TOWN OF OCEAN CITY

ADDENDUM # 1: Ocean Bowl Admin Building

Date of Addendum: 6/10/24

OCEAN BOWL ADMIN BUILDING
3RD STREET/ ST. LOUIS AVENUE
OCEAN CITY, MARYLAND

1	6/6/2024	REVISED 2 LIGHT FIXTURES
Date:	04/17/2024	
Scale:	NOTED	
Dwn By:	CULLEN	
Proj No.:	2145A005.B01	
REFLECTED CEILING PLANS		
Dwg No.:	A-103

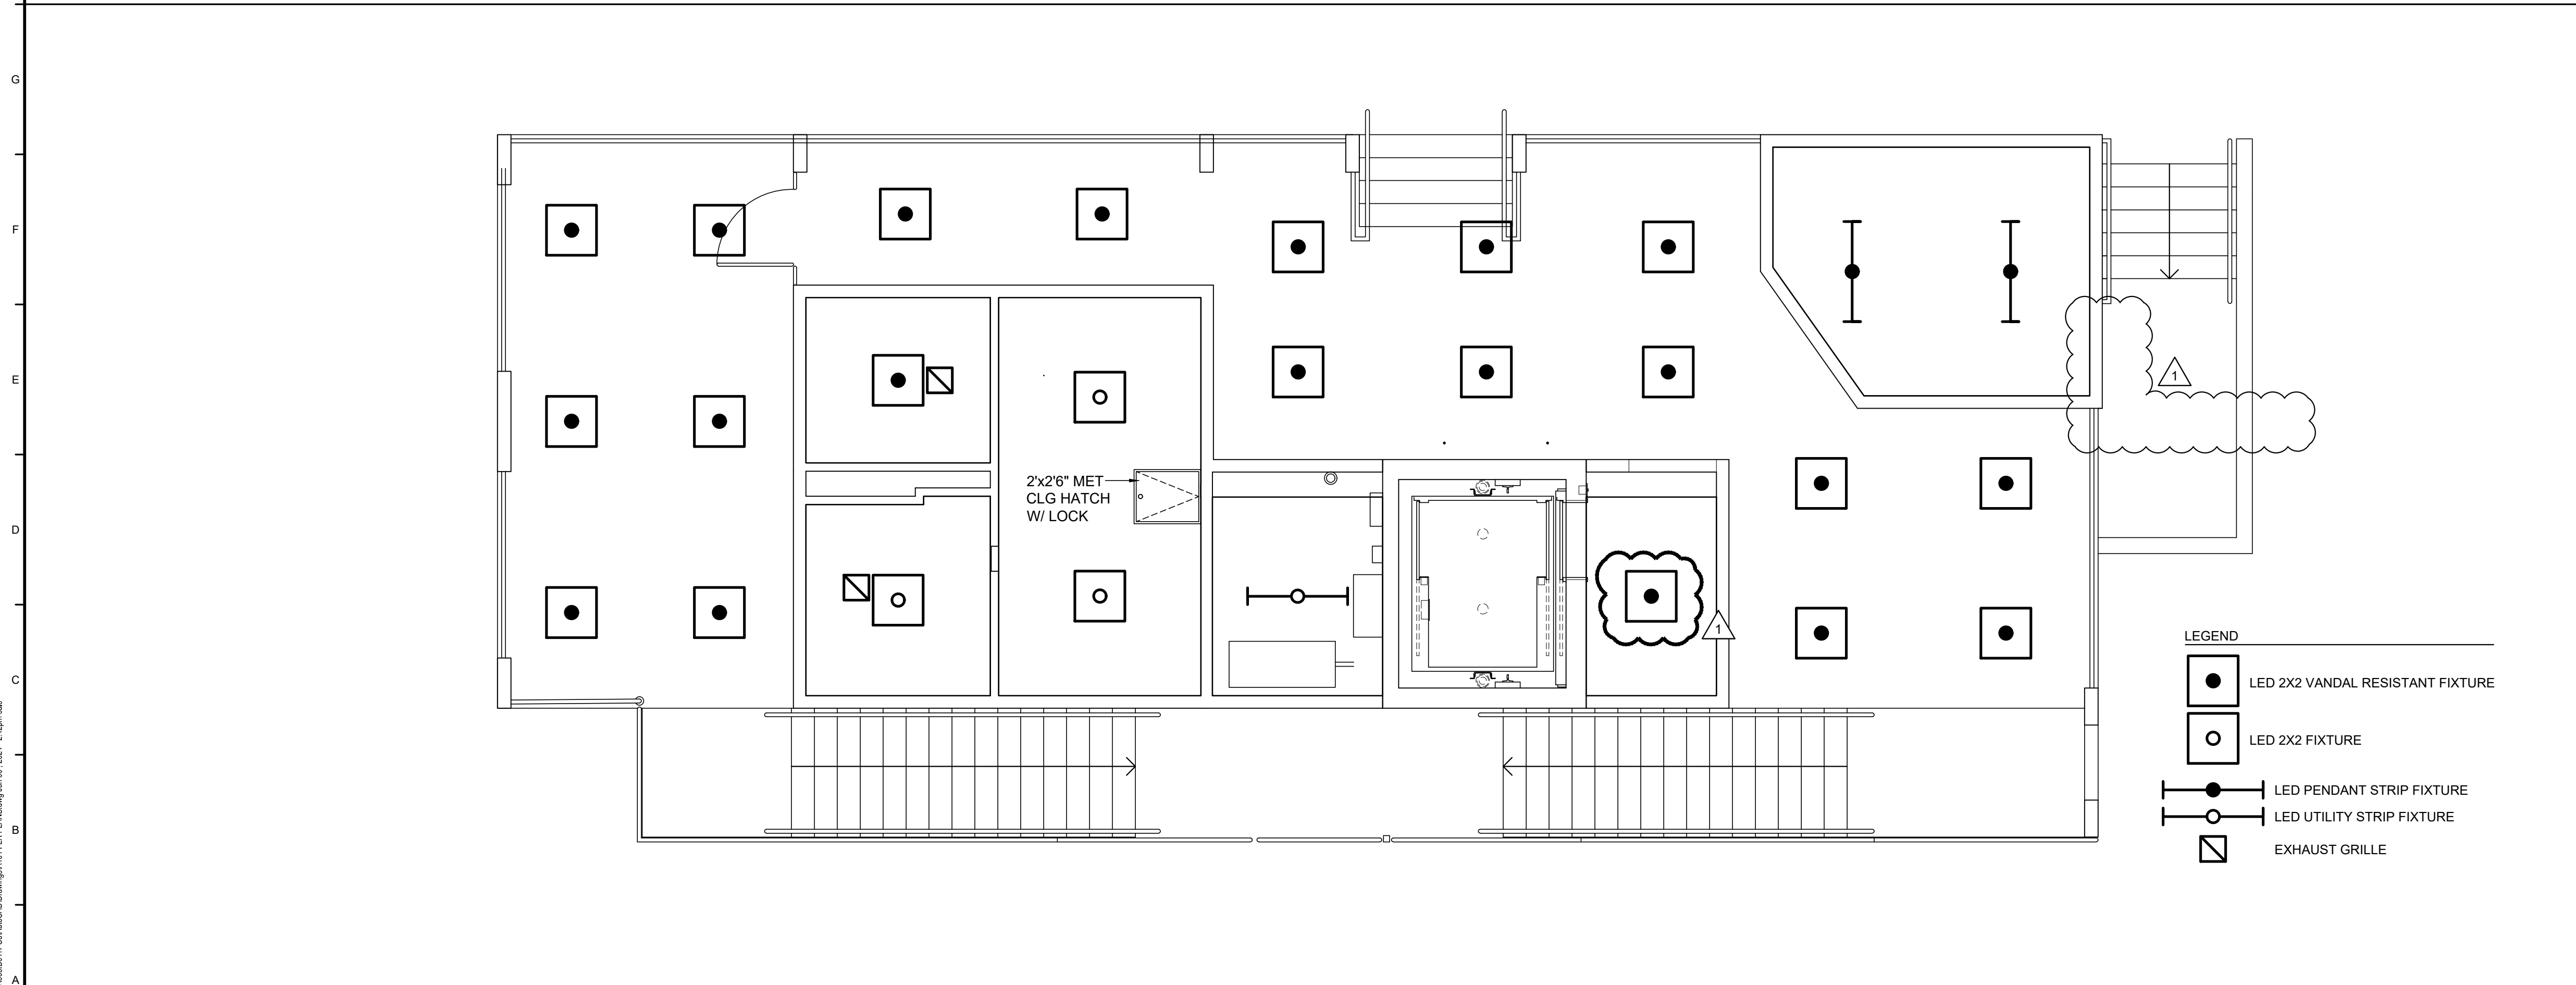
2.5	Referencing the overall project wage scale is not a requirement, correct? Refer to Scope of Work, Section #1-General, Item k.
2.6	There is a discrepancy in the light lay out and count between sheet A-103 Reflected ceiling print and sheet E-101 lighting floor plan. A – 103 shows CL lighting to be vandal resistant, there are 2 that are Not marked, plus the 2 that are missing, I believe all the CL fixtures Should be vandal resistant as they are all in common areas. Also, there are 3 lights in the elevator pit marked VL on sheet E – 101 The fixture schedule on sheet E – 301 has no listing for a VL fixture, It does list an LW, which I believe are the pit light fixtures. A-103 has been revised to show all the lights in common areas to be vandal resistant. LW is the fixture to be used in the Elevation Pit, it is to be as follows: Lithonia DMW2 L24 4000LM PCL MD MVOLT GZ10 40K 80CRI

WALL SECTIONS

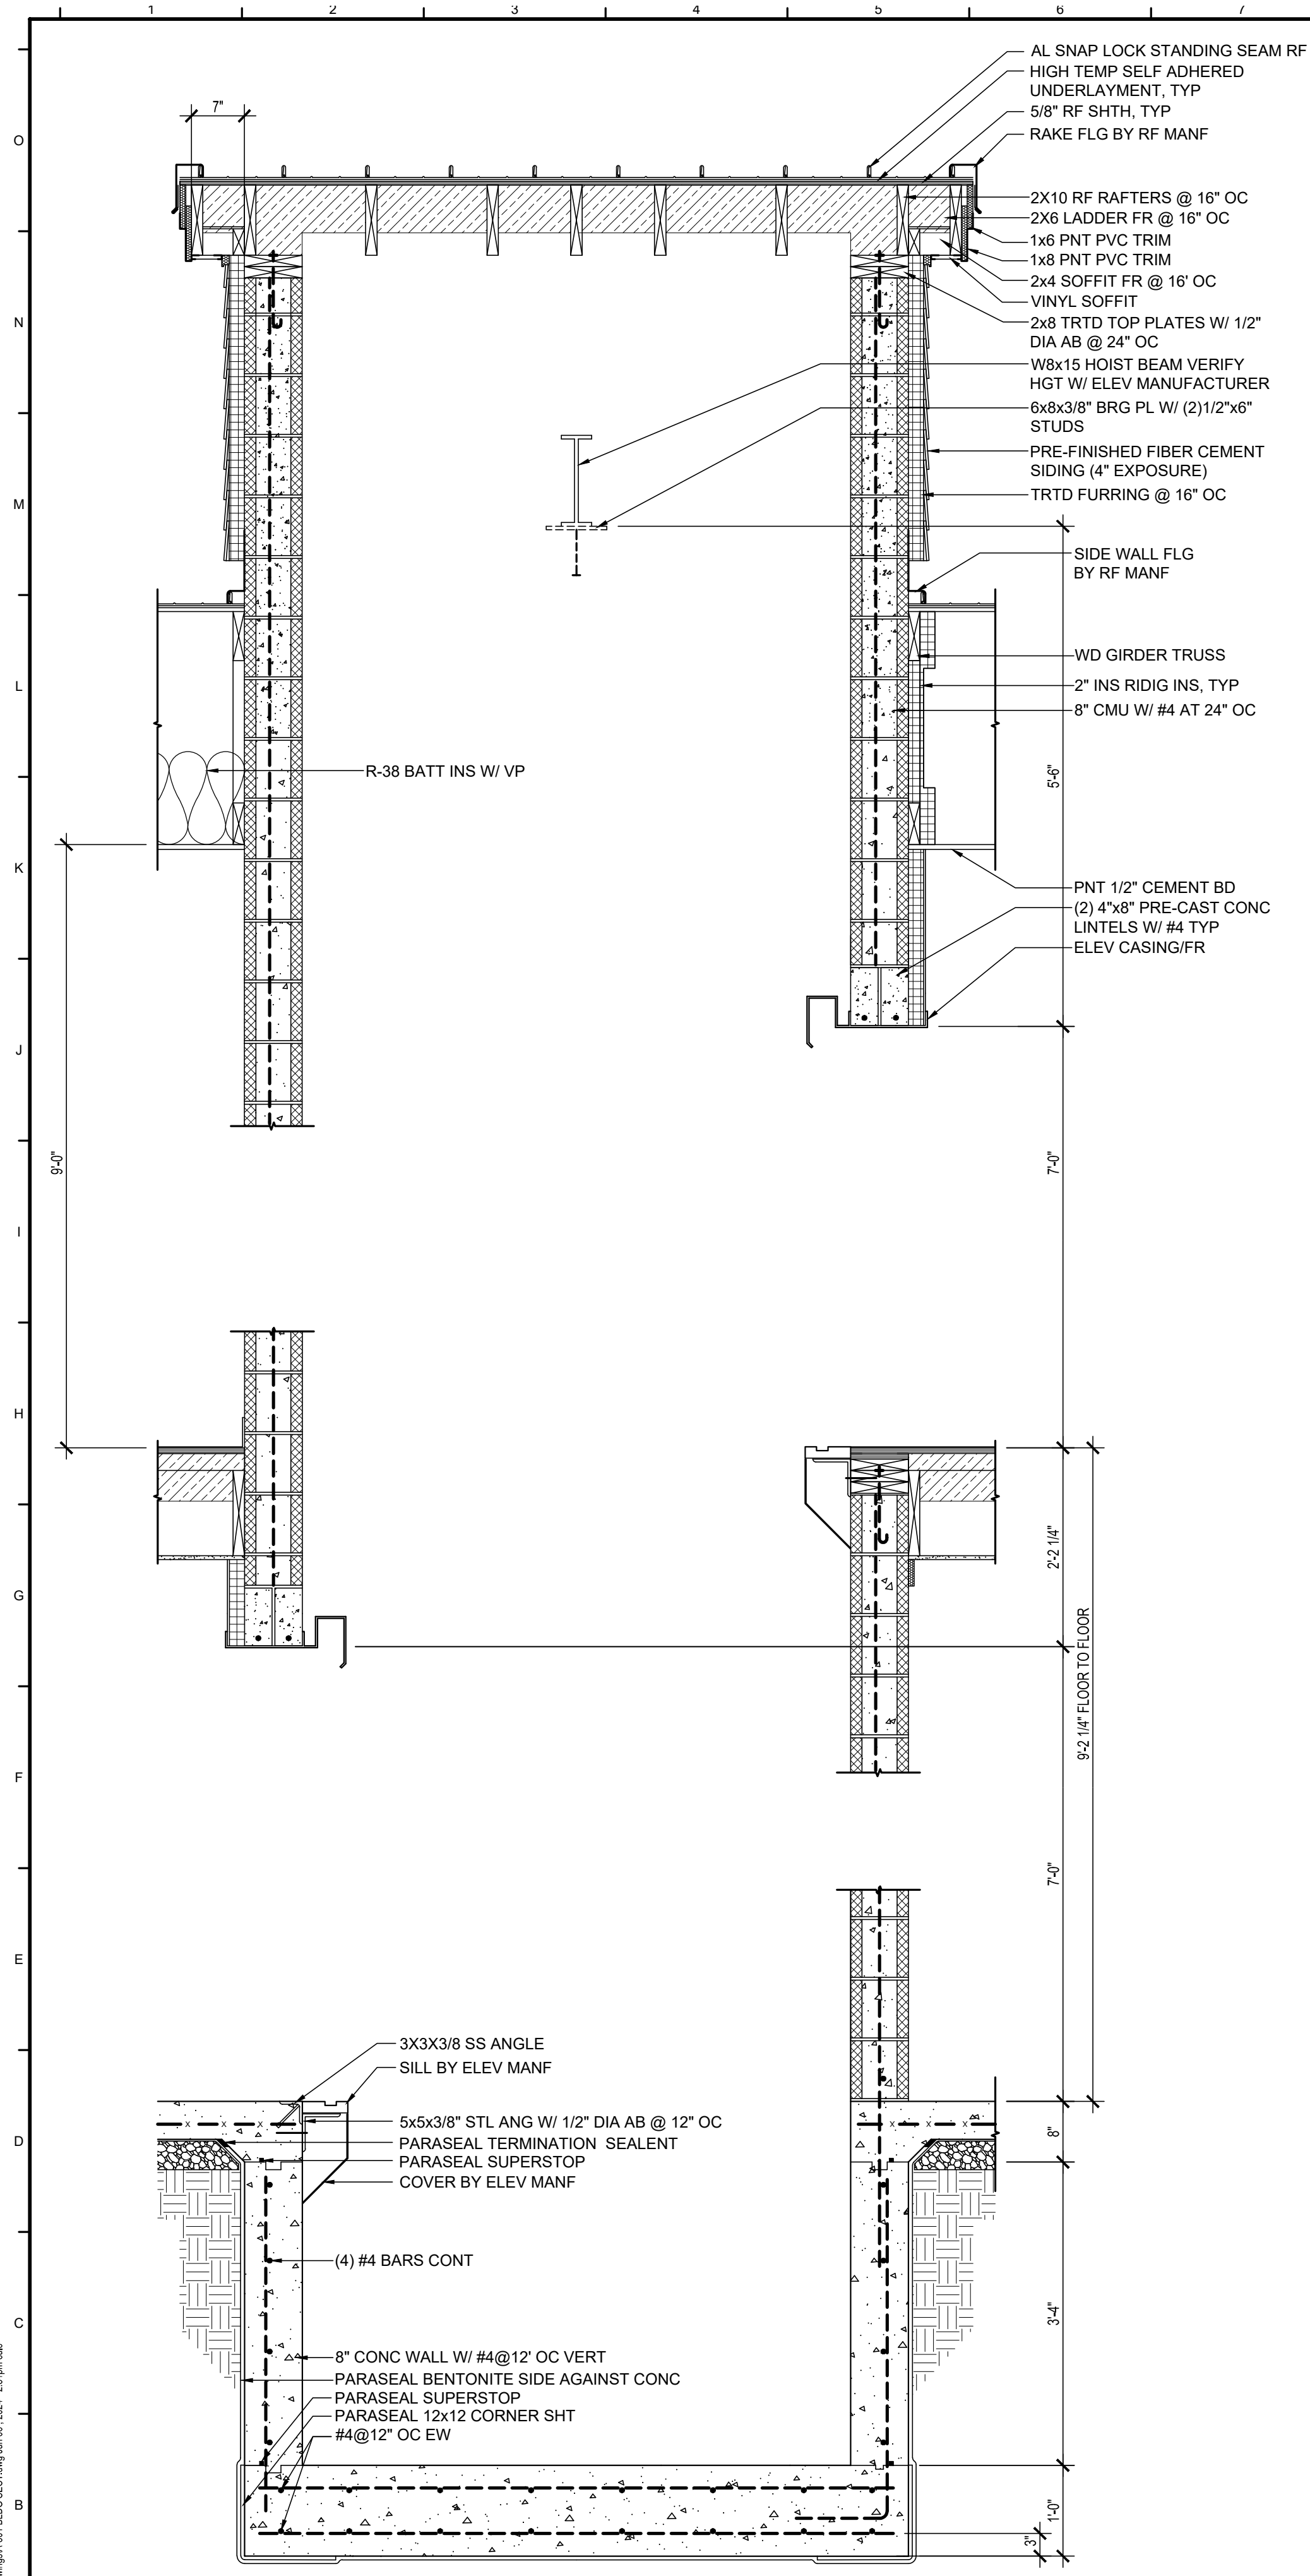
1.5	What size are the pickets for the exterior railing? The drawings incorrectly lists them as 1/2" in diameter. They are to be 3/4" in diameter.
1.6	Will this project be requiring any window treatments such as shades or blinds? If so where and what type? No window treatments are not part of the scope of work.

NO.	DATE	REVISION
1	04/17/2024	REVISED PICKET SIZE

Dwg No.: **S-101**

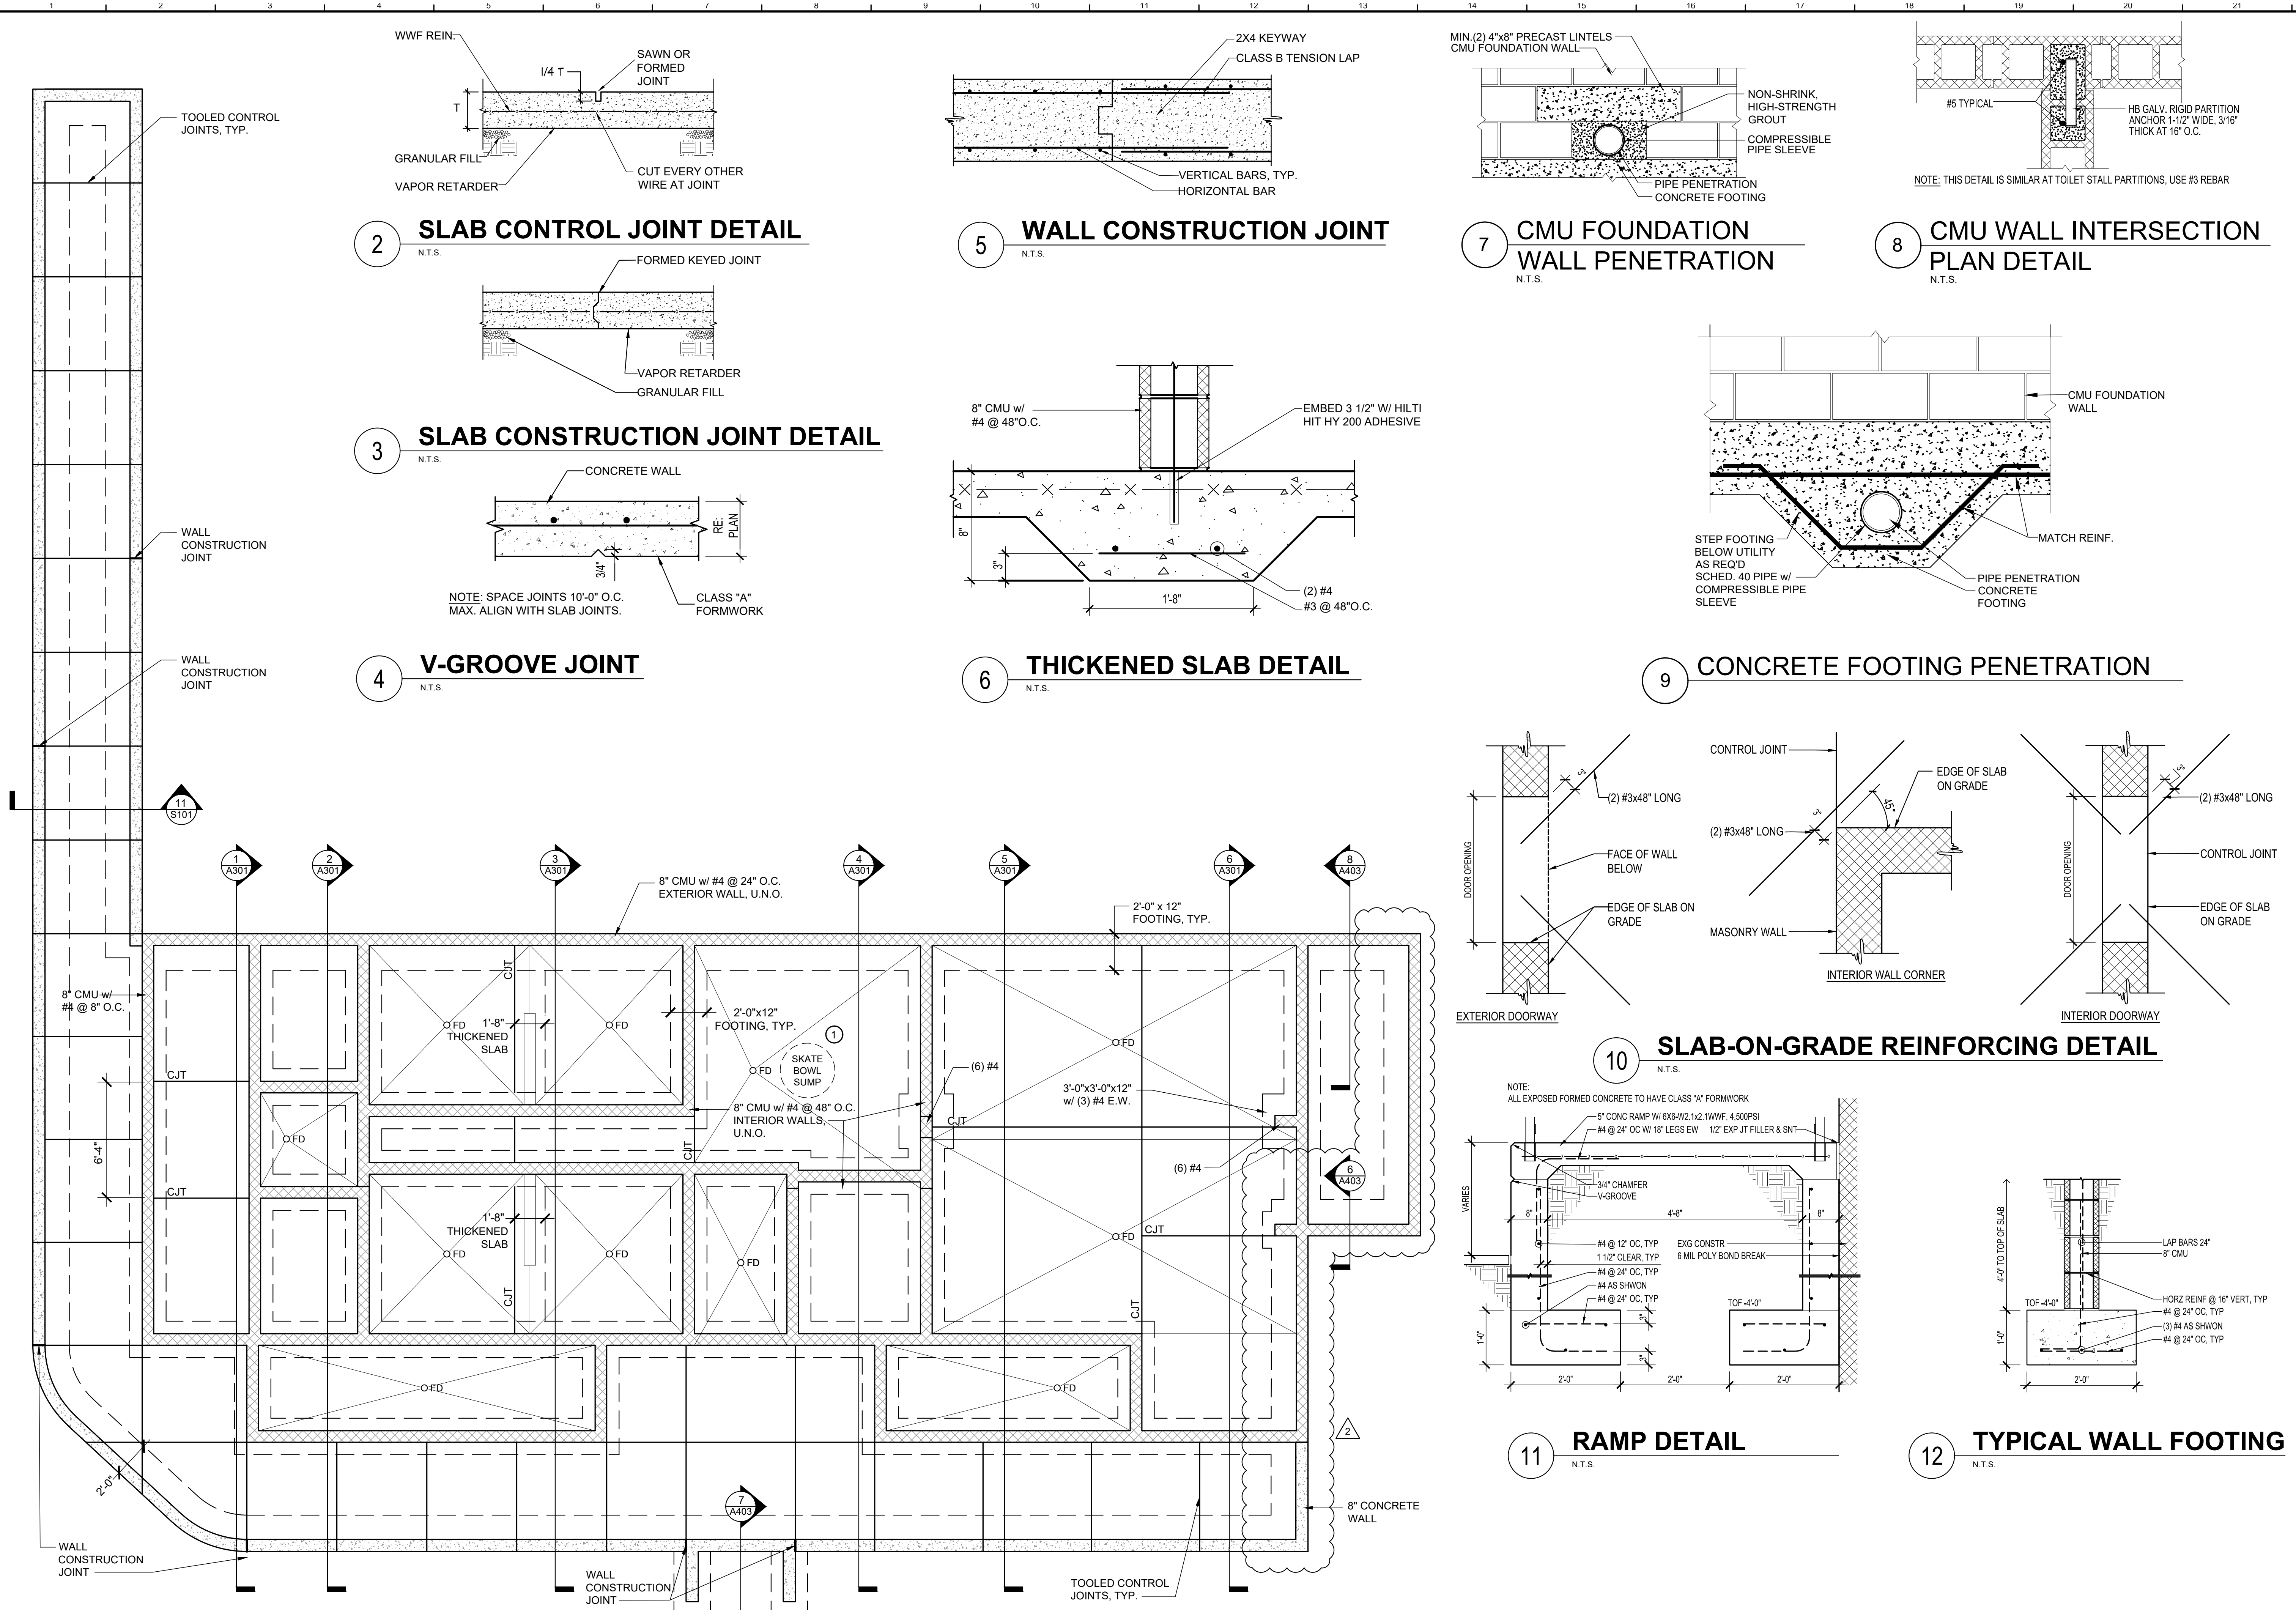
1 7/3/2023 REDUCED SCOPE
2 6/6/2024 REVISE FOUNDATION ALONG EAST SIDE OF BLDG
